ATTACHMENT 3

PROPOSED TECHNICAL SPECIFICATIONS

Marked-up Technical Specifications Pages,

5-1
B 3/4 6-1
B 3/4 6-2

CONFIGURATION

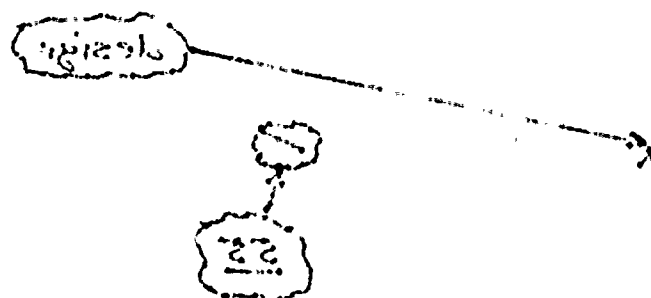
5.2.2 The containment building is designed and shall be maintained for a maximum internal pressure of 55 psig and a temperature of 283°F. The containment building is also structurally designed to withstand an internal vacuum of 2.5 psig.

design

55

5.2.2 The containment building is designed and shall be maintained for a maximum design internal pressure of 55 psig and a temperature of 283°F. The containment building is also structurally designed to withstand an internal vacuum of 2.5 psig.
